ECE/TRANS/WP.29/GRSP/2006/7
3 March 2006

PROPOSAL FOR DRAFT AMENDMENTS TO DRAFT GLOBAL TECHNICAL
REGULATION (GTR) ON PEDESTRIAN SAFETY

Transmitted by the expert from the United States of America

ATTACHMENT 2

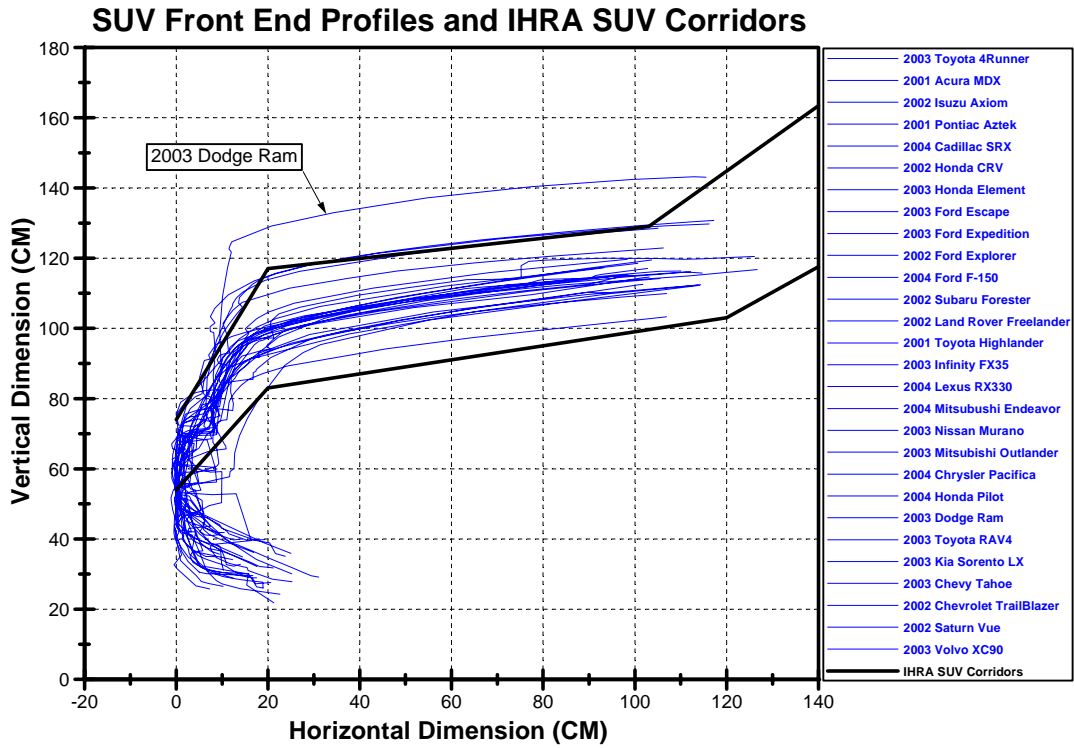
The United States of America (US) has completed an assessment of its vehicle fleet based on Gross Vehicle Mass (GVM) (see Attachment 1) and has compared the fleet's profiles to corridors developed by International Harmonised Research Activities (IHRA) (see Attachment 2). Based on these observations, the US believes that the upper limit of 2.5 tonnes is not sufficient to encompass all the vehicles that fit into the IHRA corridors. Limiting the GVM to 2.5 tonnes would exclude from this gtr most of the sport utility vehicles (SUVs) and pick-up trucks in the US market. Additionally, it also excludes almost all of the min-vans, including the Dodge Grand Caravan and Toyota Sienna, and some of the large 4-door passenger cars, such as Audi A8 and the Lincoln Town Car. The SUVs, pick-up trucks, and mini-vans comprise a large percentage of the total US passenger vehicle fleet.

During the discussions on applicability in the informal working group, applying this gtr to vehicles with a GVM not exceeding 3.5 tonnes was also considered. After reviewing the fleet data, the US believes that this limit is also not sufficient. Many of our largest SUVs have vehicle profiles that are within the IHRA corridors, yet have a GVM greater than 3.5 tonnes. Of the vehicles measured, only the 2003 Dodge Ram was well outside the IHRA corridors, but based on US head impact testing (INF GR/PS/132), this vehicle should meet the gtr requirements.

The US recommends the applicability paragraph make no reference to the mass of the vehicle. When the gtr is adopted each jurisdiction can decide to restrict the application in its domestic regulation as appropriate.
